14 CFR Parts 25 and 121
Improved Flammability Standards for
Materials Used in the Interiors of
Transport Category Airplane Cabins

[Docket No. 24594; Amdt. Nos. 25-61 and 121-189]

ACTION: Final rule; Request for additional comments.

Figure 1. Release Rate Apparatus

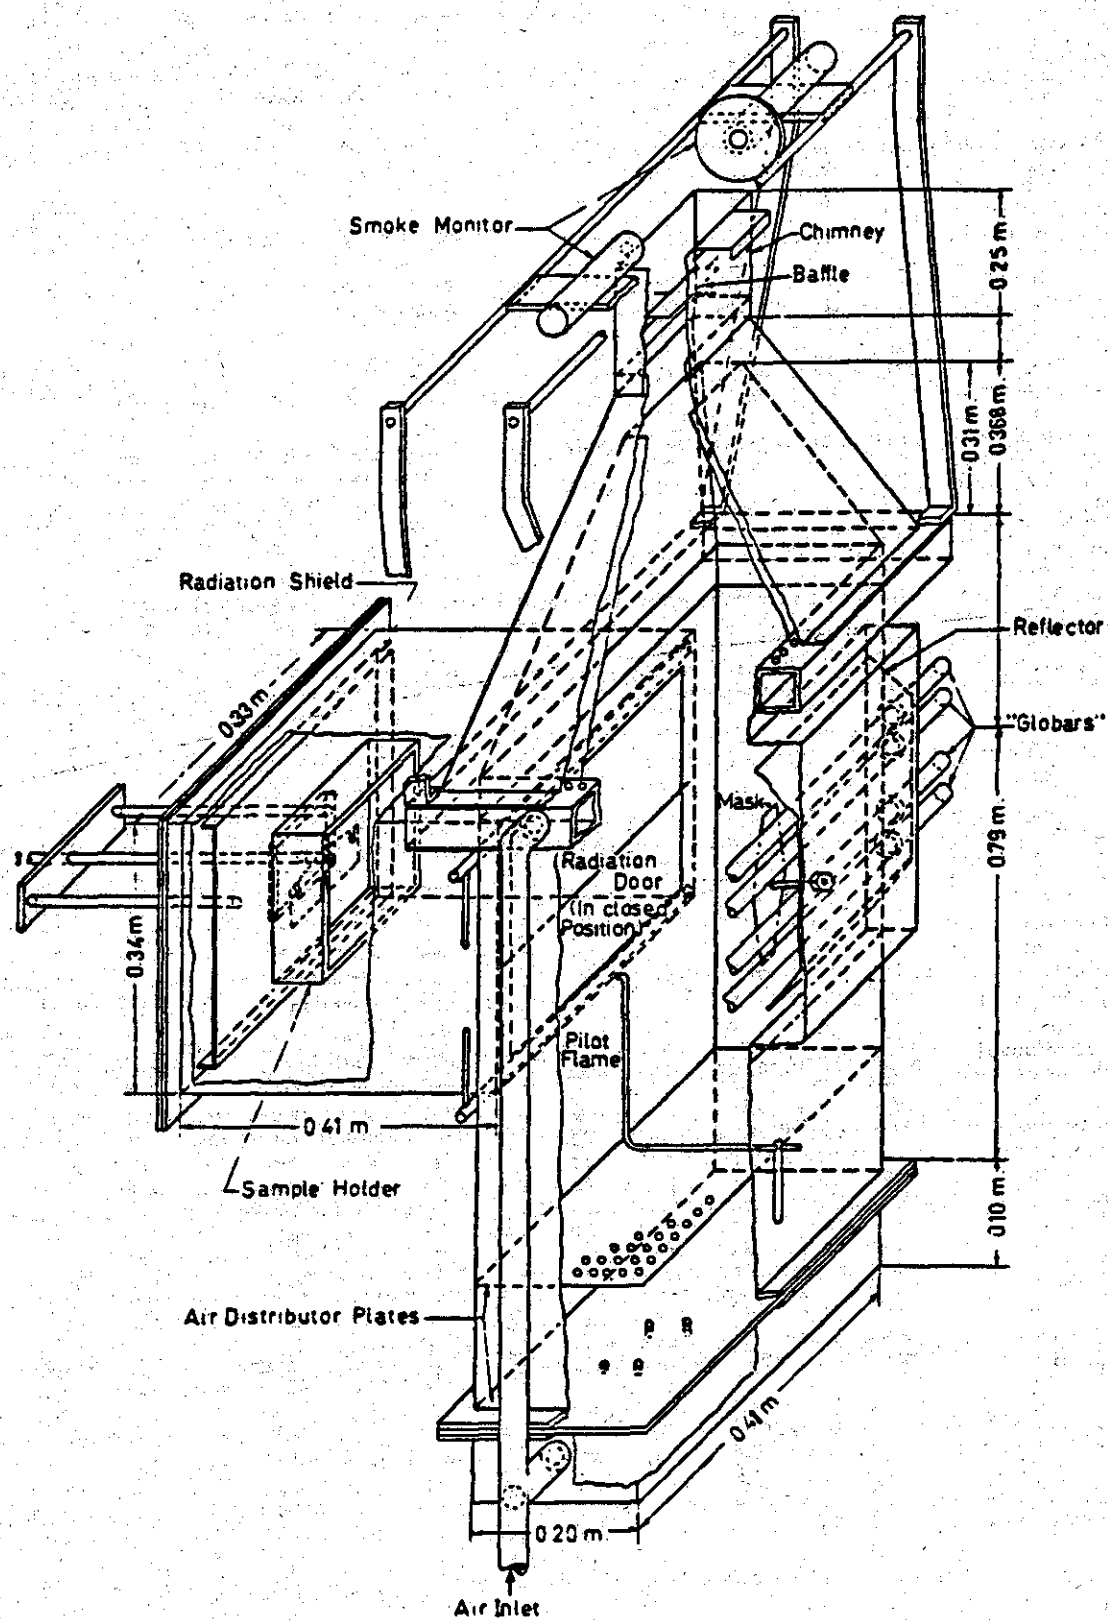
Several commenters note deficiencies in the figures that describe the test apparatus, particularly Figure 1. The figures have been revised to correct these deficiencies and to reflect other changes believed necessary by the FAA. Other commenters note typographical errors in the text of the proposed rulemaking which have been corrected.
